State of New Mexico
 Energy, Minerals and Natural Resources
HOBBS OCD
 OIL CONSERVATION DIVISION
 1220 South St. Francis Dr.
 Santa Fe, NM 87505

SUNDRY NOTICES AND REPORTS ON WELLS (DO NOT USE THIS FORM FOR PROPOSALS TO DRILL OR TO DEEPEN OR PLUG BACK TO A DIFFERENT RESERVOIR. USE "APPLICATION FOR PERMIT" (FORM C-101) FOR SUCH PROPOSALS.) 1. Type of Well: Oil Well <input checked="" type="checkbox"/> Gas Well <input type="checkbox"/> Other <input type="checkbox"/>		WELL API NO. 30-025-05298

4. Well Location Unit Letter <u>B</u> : <u>660'</u> feet from the <u>North</u> line and <u>1815'</u> feet from the <u>East</u> line Section <u>11</u> Township <u>15S</u> Range <u>37E</u> NMPM County <u>Lea</u>		7. Lease Name or Unit Agreement Name Denton ✓

Fasken Oil and Ranch, Ltd. Proposes to plug and abandon the Denton No. 11 as proposed on the attached procedure. Also attached is the current and proposed wellbore diagram.

PROPOSED

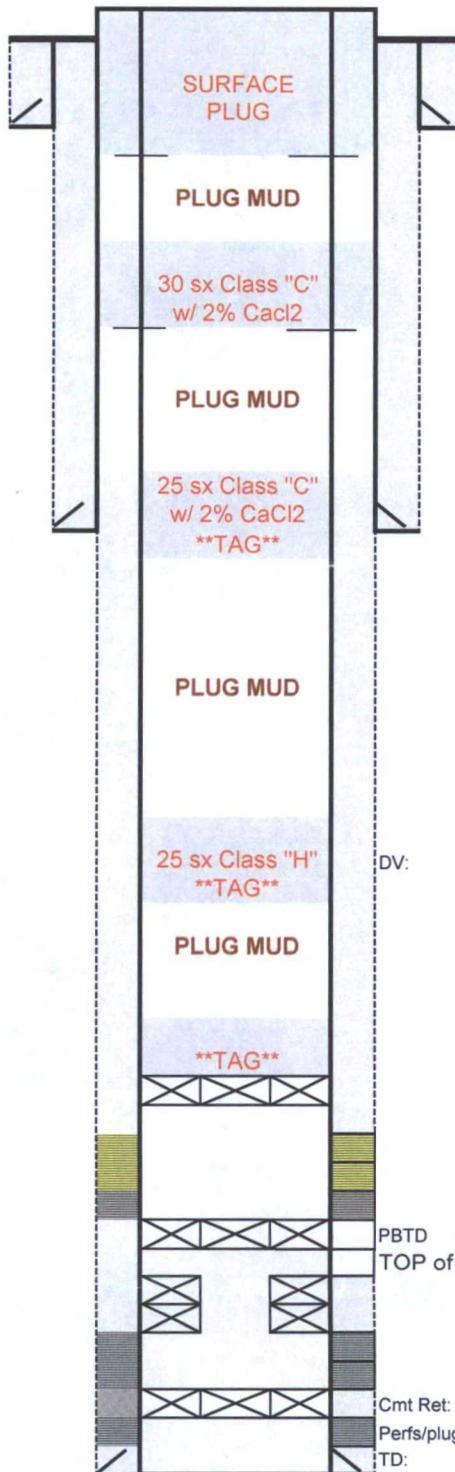
NOTE CHANGES TO ATTACHED PROCEDURE

16. POW and LD all but 1600' of tubing. Stand back remainder in derrick. *← Base Salt Plug Perf @ 3100, 50Z w/30SX WOC & TAG*
17. RUWL. RIW and perforate 5-1/2" casing at 2120' (4 holes, 1 jspf). POW and confirm shots fired. *T. ANHY*

27. ND BOP, RDPU and clean location.
28. Empty steel pit, cut off mast anchors, release all rental equipment.
29. Cut off casing 3' below ground level. *VERIFY CMT TO SURFACE ALL STRINGS*
